USB Power Delivery ENGINEERING CHANGE NOTICE

Title: Delay of VCONN_SWAP

**Applied to: USB Power Delivery Specification Revision 3.2
Version 1.0**

Brief description of the functional changes proposed:
This ECN allows the VCONN provider to send WAIT response if the far-end port supports same or newer specification revision. The ECR also requires that a port delays its future VCONN_Swap request by at least tVconnSwapDelay* after losing VCONN ownership.

Figure 8-193 “VCONN Swap State Diagram”

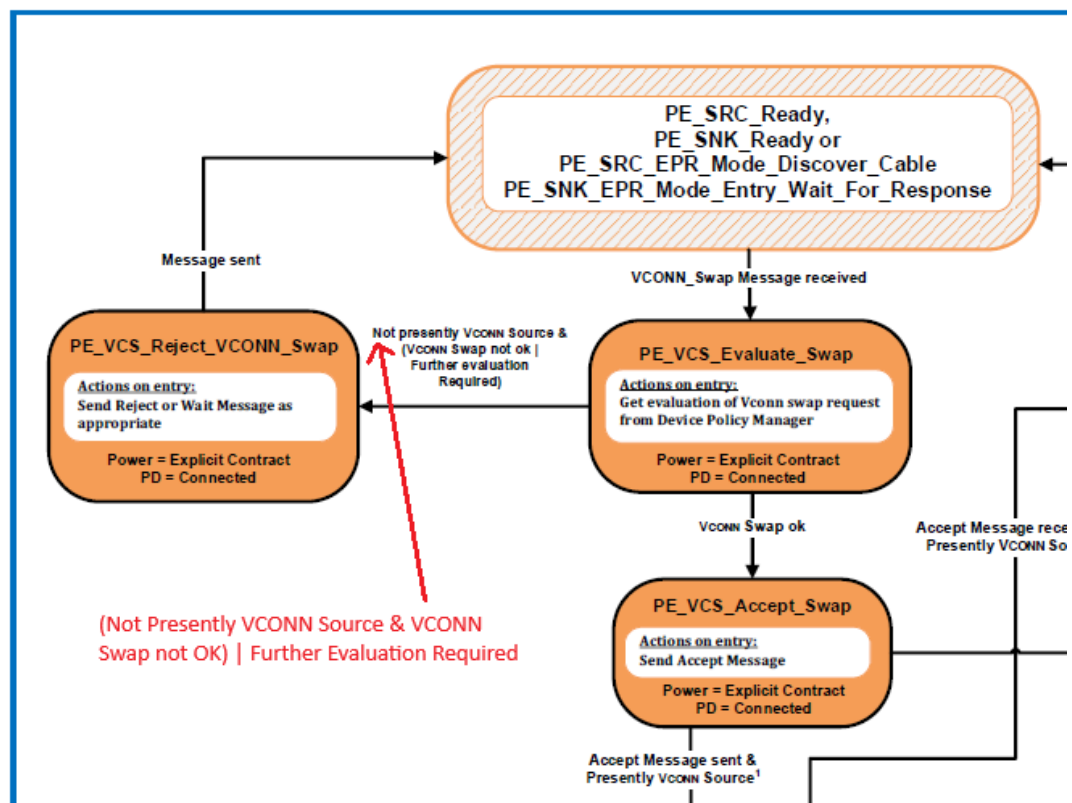
(g). 8.3.3.21 VCONN Swap State Diagram, Page 959
